RE: West 11th Avenue Tentative Subdivision Map (S 17-09)
443, 521, 525 West 11th Avenue, 043-800-013, -015, and -017

RE: **Tentative Subdivision Map S 17-09 West 11th Avenue Subdivision**

This office has reviewed the Tentative Map S 17-09 West 11th Avenue Subdivision and herewith submits the following findings and recommendations for same.

**SMALL LOT SUBDIVISION
 TENTATIVE SUBDIVISION MAP
 WEST 11th AVENUE SUBDIVISION
 S17-09
 A PUBLIC STREET SUBDIVISION
 FOR
 ZACH PLOTTEL
 A PORTION OF LOT 4
 "BIDWELL 4th SUBDIVISION"**

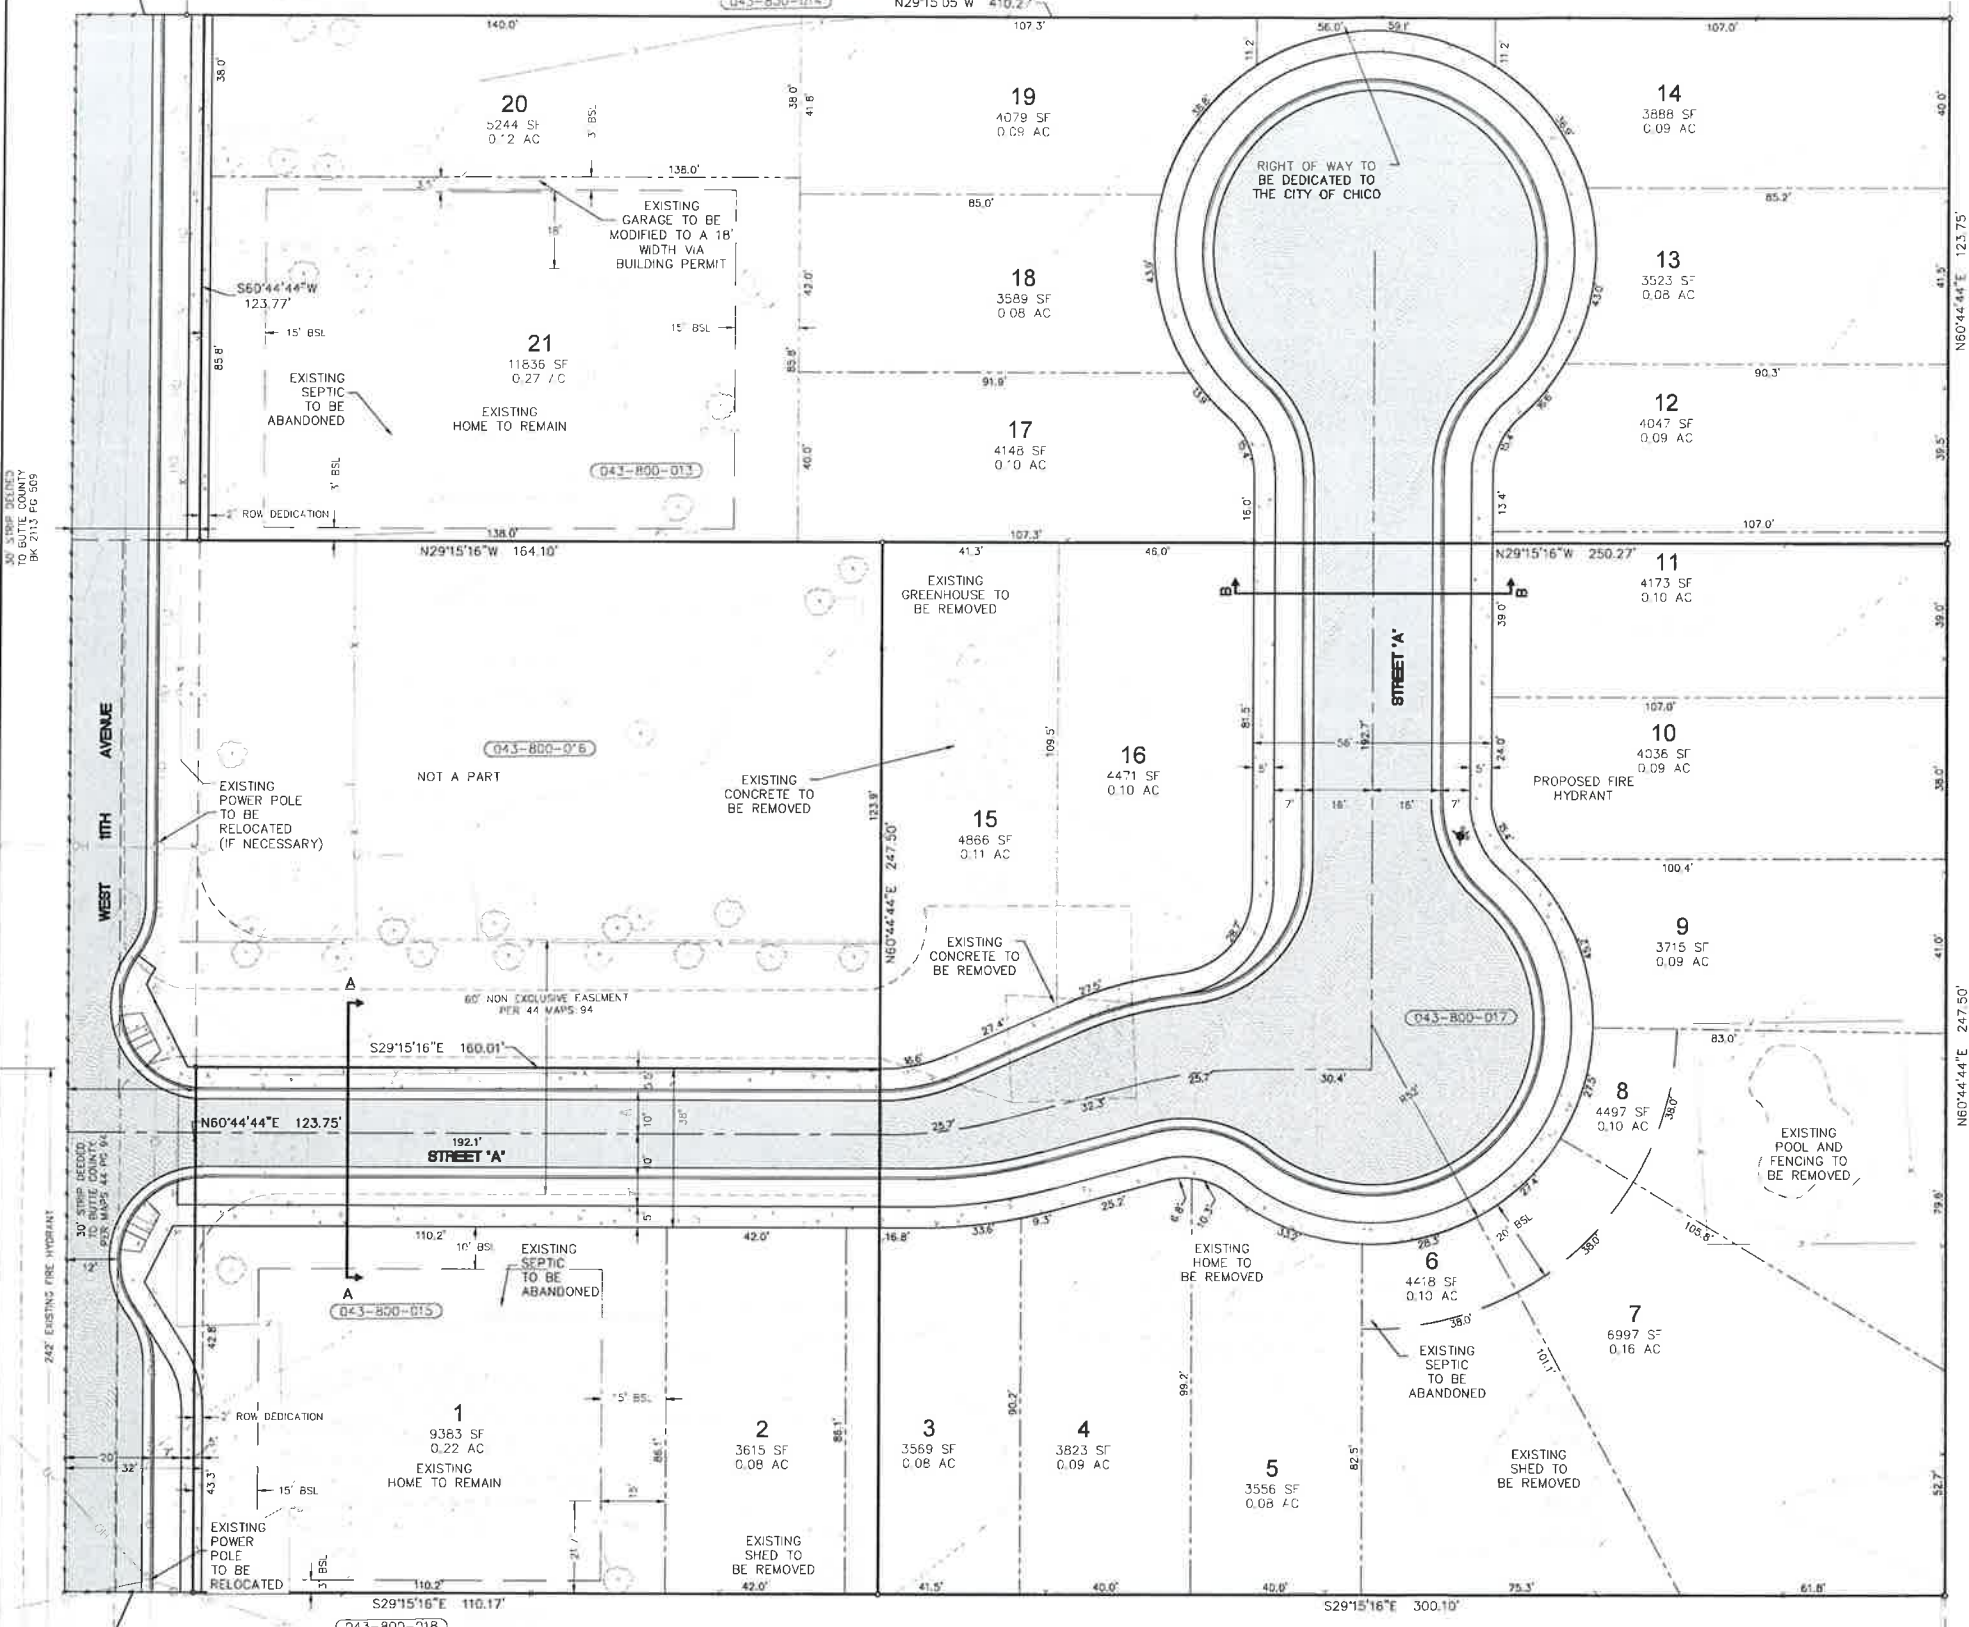
1. **Request:** Allow non-standard lot width to depth ratio for lot 20.

2. **Request:** Allow non-standard street section at entrance.

3. **Request:** Allow non-right angled or radial lot lines to street frontage.

- LOT 20 HAVE MORE DEPTH THEN ALLOWED IN THE 3:1 WIDTH TO DEPTH RATIO (18R.08.010.C.2)
- NON-STANDARD STREET SECTION AT ENTRANCE
- NON-RIGHT ANGLED OR RADIAL LOT LINES TO STREET FRONTAGE

Recommendation: Acceptable.

Recommendation: Acceptable.

Recommendation: Acceptable.
